**Proposal for amendments to  
 ECE/TRANS/WP29/GRRF/2014/26**

**I. Proposal**

Annex 3, replace:

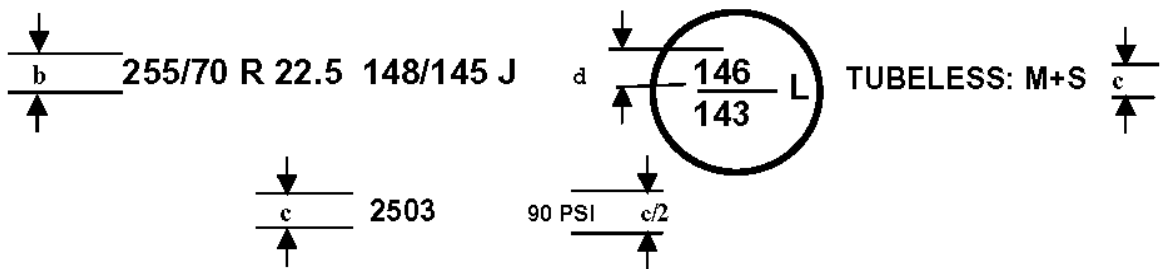
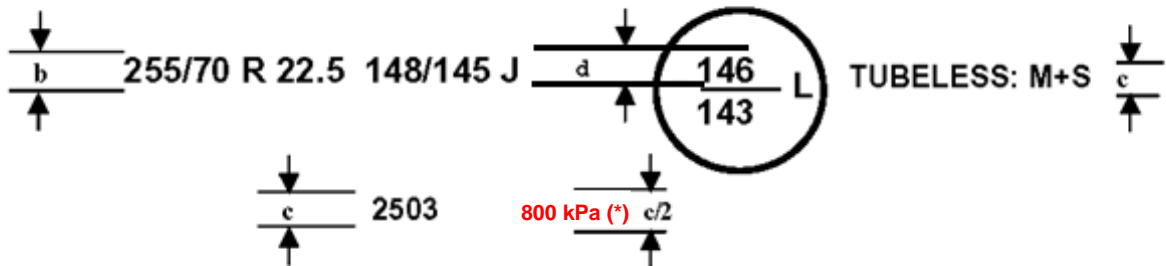
(\*PSI marking instead of kPa may be used for tyres first type approved before 1 November 2016. "

1. Paragraph 3.1.10 should clearly indicate that the pressure marked on the sidewall has to be the same as the one declared by the tyre manufacturer.
  2. In Regulation No. 54. Rev. 3, paragraph 4.1.12 should give the possibility to declare the test pressure in kPa when appropriate.
  3. In document GRRF/2014/26, the proposal for the new marking leave the "90 PSI" visible although it should be replace by "800 kPa (\*)"
-
